September 25, 2013

Re: Facility No. 9-9708  
5910 MacArthur Boulevard, Oakland, CA

Subject:  
Data Gap Investigation Workplan  
Former Chevron Service Station No. 9-9708  
5910 MacArthur Boulevard  
Oakland, California  
*Fuel Leak Case No. RO0000124*

**SITE PLAN WITH PROPOSED SOIL BORING AND MONITORING WELL LOCATIONS**

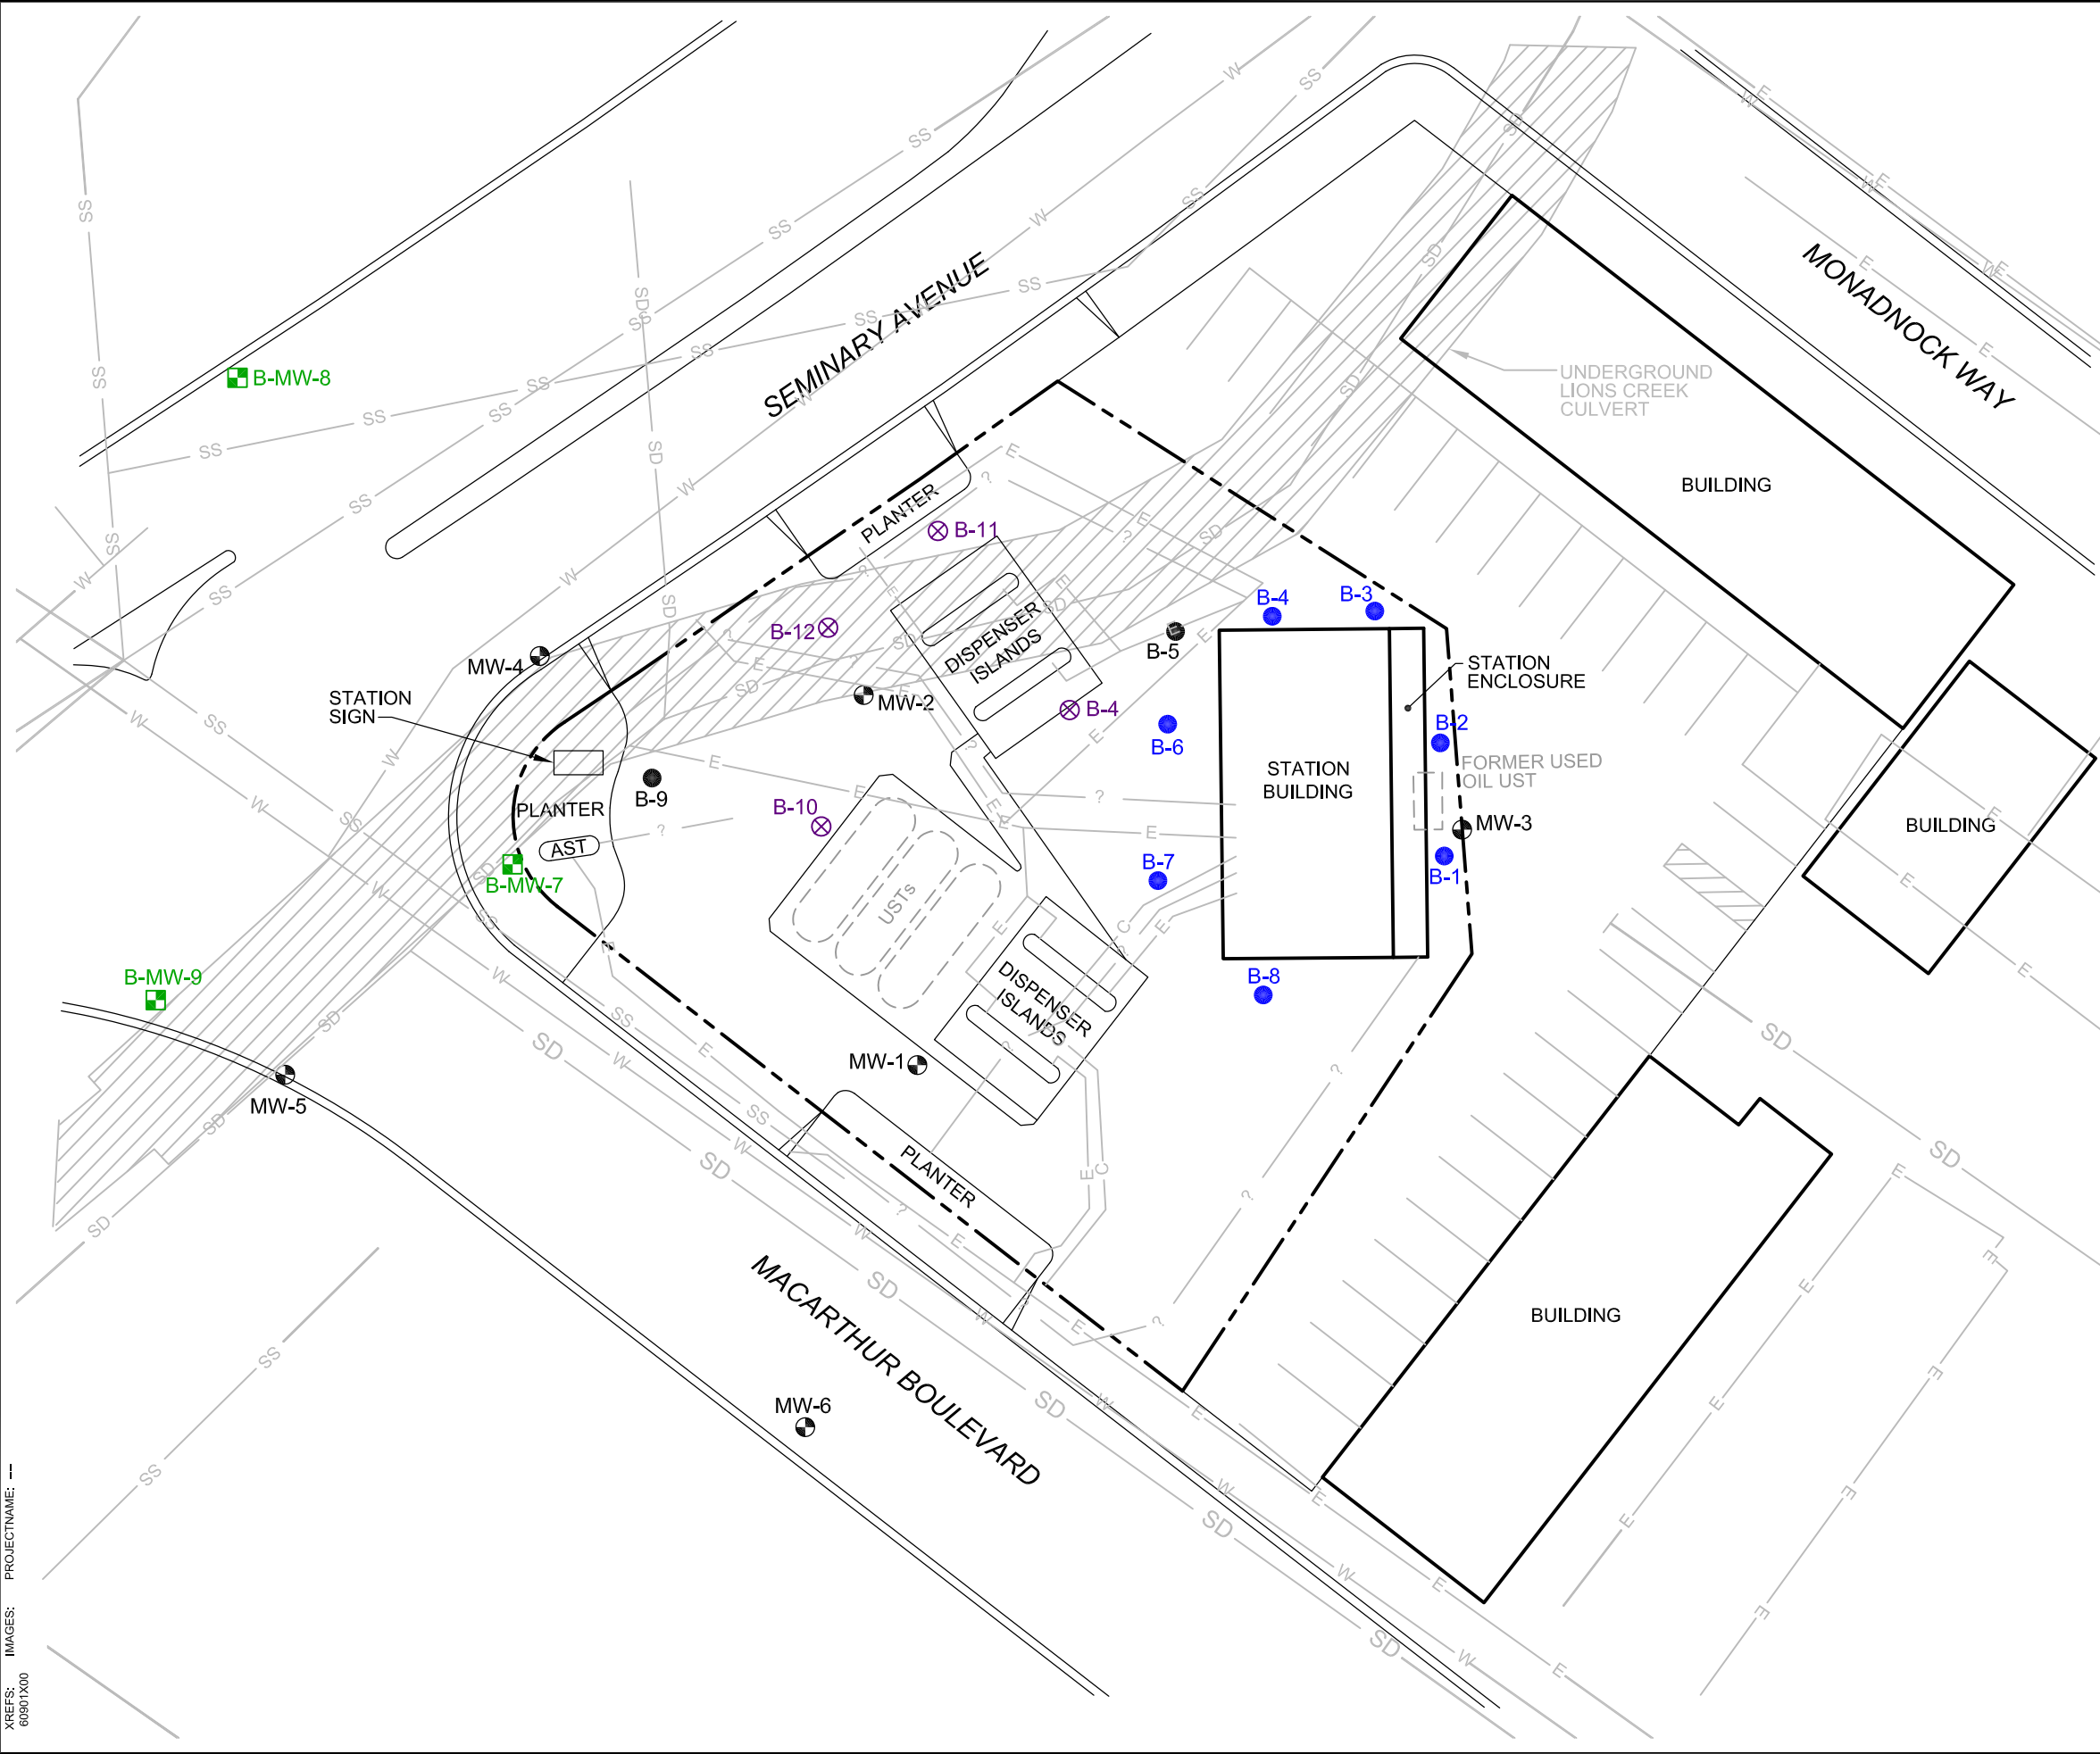
- 1. General Criteria e – SCM Deficiencies – The March 2013 Site Conceptual Model (CSM) submitted for the subject site appears to be deficient in a number of aspects that directly affect site hydrology and plume length at the site. Our review of the case fields indicates that insufficient data and analysis has been presented to support the SCM. This analysis considered the following site specific data.*

3. *LTCP Media Specific Criteria for Groundwater – To satisfy the media-specific criteria for groundwater, the contaminant plume that exceeds water quality objectives must be stable or decreasing in areal extent, and meet all of the additional characteristics of one of the five classes of sites listed in the policy.*

One soil boring (B-12) and three monitoring wells (B-MW-7, B-MW-8 and B-MW-9) will be advanced to characterize the underground Lion Creek Stream Channel, complete delineation of groundwater and to assess how the channel affects groundwater flow on and off-site. Boring B-12 is located in the area where the channel is presumed to be. The boring will be advanced using an air-knife to attempt to locate the top of the stream channel culvert. Soil samples will be collected at this boring. Proposed boring and well locations can be found on Figure 2.

**ARCADIS Response:** Three soil borings (B-10, B-11 and B-12) and three monitoring wells (MW-7 , MW-8 and MW-9) will be advanced to define the downgradient extent or flow path of the contaminant plume. Temporary monitoring wells will be installed in borings B-10 and B-11. Water levels will be measured in both temporary and permanent wells. Groundwater levels measure in the permanent monitoring wells will help assess how the channel may affect groundwater flow on and off-site. Groundwater and soil borings will also be collected at these locations. Proposed boring and monitoring well locations can be found on Figure 2.

All boring and monitoring well locations will be advanced with a hollow stem auger rig to a total depth of approximately 20 feet below ground surface (bgs) to delineate the extent of soil and groundwater impacts in the vicinity of the hydrocarbon USTs, and to assess how the underground Lion Creeks Stream Channel affects groundwater flow on and off-site. Borings will be drilled into the top of the clay layer, but will not be advanced through it, to minimize the potential for vertical migration below this potential impermeable barrier. The proposed drilling locations are shown on Figure 2.
